HUSQVARNA TECHNICAL BULLETIN HTB2106

JUNE 25, 2021

RECALL: THIS MODIFICATION HAS TOP PRIORITY AND MUST BE PERFORMED IMMEDIATELY TO ENSURE CUSTOMER SAFETY

CHECKING THE MOUNTING POSITION OF THE LICENSE PLATE HOLDER

Fig. 1

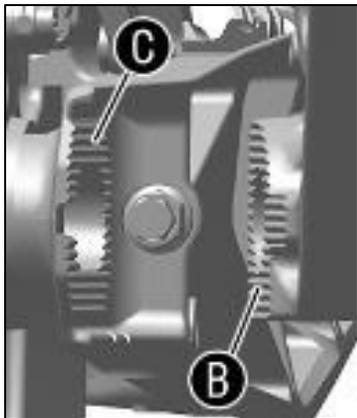
1. Visually check the alignment of the gear teeth on the license plate carrier (B) and swingarm (C). (Fig. 1-3) to verify that they are aligned with each other.
2. If the alignment of the gear teeth on the license plate carrier (B) and swingarm (C) **is correct** as shown in Fig. 2 then retighten rear wheel axle collar nut to 90 Nm to complete the inspection.
3. If the alignment of the gear teeth on the license plate carrier (B) and swingarm (C) **is incorrect** as shown in Fig. 3 then loosen the components and align the gear teeth on the license plate carrier (B) and swingarm (C) correctly.
4. Retighten the rear wheel axle collar nut to 90 Nm to complete the repair.
